Appeal to An Coimisiún Pleanála

Appeal Reference: D26A/0534/WEB

Site Address: 5 Sorrento Road, Dalkey, Co. Dublin

Appellant: Joe Hughes, 28 Tubbermore Road, Dalkey, Co. Dublin

Figure 6 – Privacy Impact Diagram

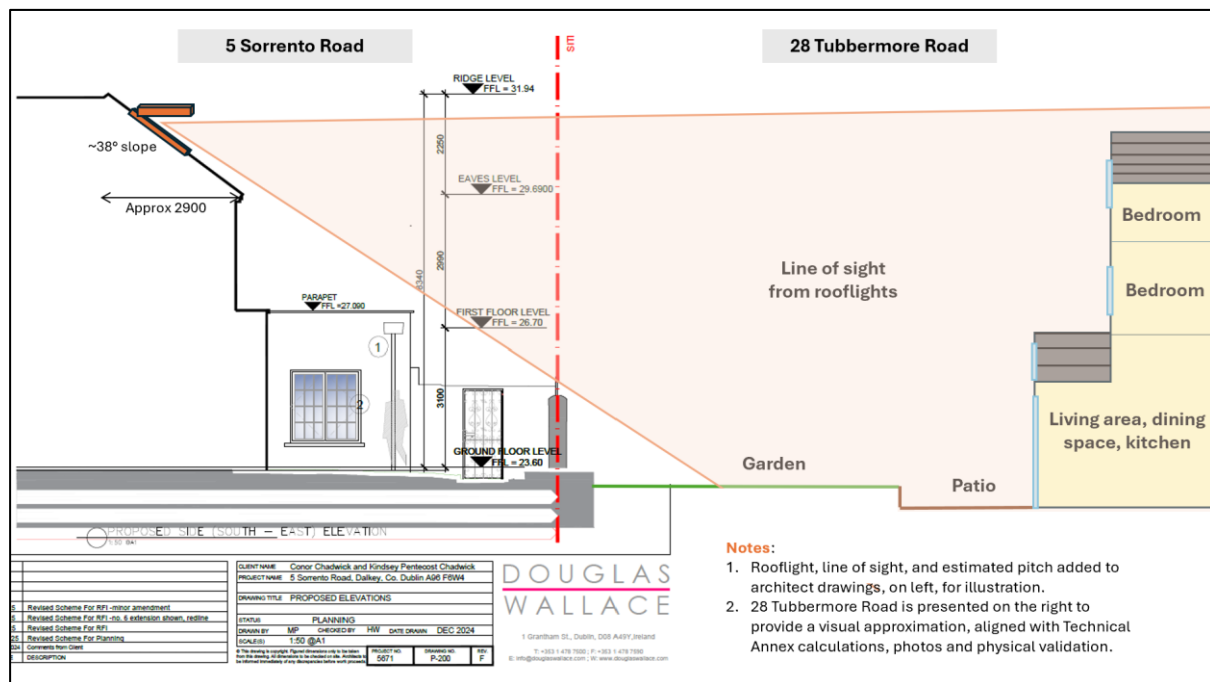
The rooflights also create a clear sightline into our rear bedrooms, further intensifying the loss of privacy across multiple habitable rooms. (**Ref: Fig 6 - Privacy Impact Diagram in the Technical Annex.**)

The architect's drawings (see Fig. 6 below) indicate:

- Vertical drop (rise): **2.25 m**
- Horizontal run: **2.90 m**

$$\theta = \arctan\left(\frac{2.25}{2.90}\right) \approx 38^\circ$$

Therefore, the rooflights sit on a roof pitched at approximately 38°, facing downward toward the rear boundary.

This is a steep downward angle and significantly increases the potential for overlooking.

Because the roof plane slopes downward at $\sim 38^\circ$:

- The rooflights face **directly toward my property**,
- They do **not** face the sky,
- They create a **direct downward sightline** into my home.

Using basic trigonometry, a rooflight located at approximately 8 m height on a 38° downward-sloping roof creates a sightline that intersects ground level at about **10.2 m** behind No. 5 Sorrento Road. As the rear elevation of my home at 28 Tubbermore Road is approximately **22 m** behind No. 5, the sightline passes through the vertical plane of my rear elevation before reaching the ground, confirming direct overlooking into my habitable rooms.

The rooflights have a clear, unobstructed downward view into my kitchen, living area, dining space, rear bedrooms, and rear garden.
